## Land off Highfield Road, Sheppey Post Submission Response

205427

## Technical Note

Project	Land of Highfield Road, Sheppey	Job No	1000007836
Subject	Highways Review – Technical Note	Issue	02
Prepared by	Rob Franklin	Date	12/04/22
Approved by	Ben Meekings	Date	12/04/22

Figure 3: MFS 2 Extract

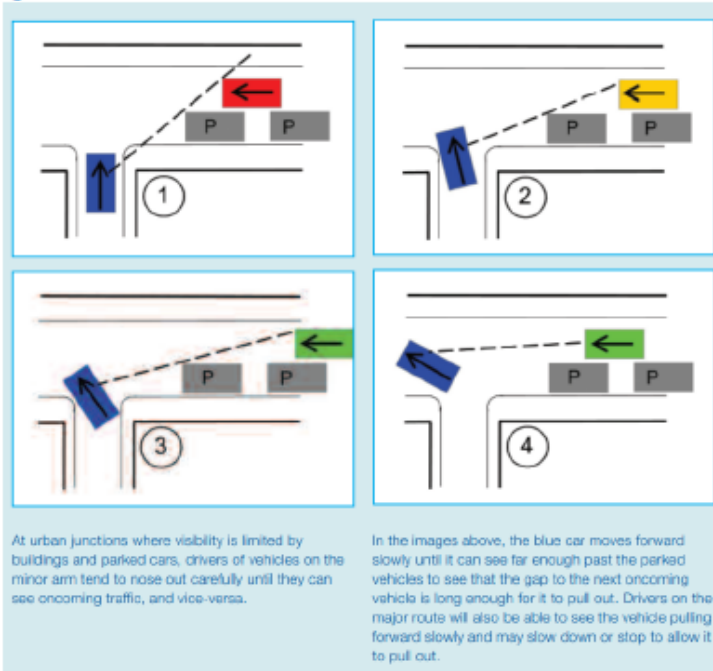
- 1.14 We do not agree with PCL that parking restrictions are required to restrict vehicles from parking within the visibility splay. PCL state that a site visit was undertaken in March 2022 and from this single visit they concluded that cars often park on the southern side of Highfield Road, close to the proposed access location. It's unclear how a site visit on one day can lead to the conclusion of this being an often occurrence. However, whilst it could be the case that on street parking does occur along Highfield Road, and this may impact on visibility splays at the proposed junction, we do not consider this to be an issue as explored further below. It is also notable that this issue has **not** been raised by the Highway Authority (KCC) as a concern.

- 1.15 The residential area surrounding the site has numerous T-junction arrangements and driveway accesses where there are no parking restrictions to restrict parking within visibility splays. **Figure 1** shows the junction where there are parking restrictions and where there are not.

1.20 **Figure 3** is taken from MfS 2 shows how this access would work practice.

1.21 Given that traffic volumes are low and speeds are low (see table 1), then we do not consider this to be an issue. Parking is commonplace within the adjacent residential areas close to junctions and driveway accesses, yet the network is proven to operate safely.
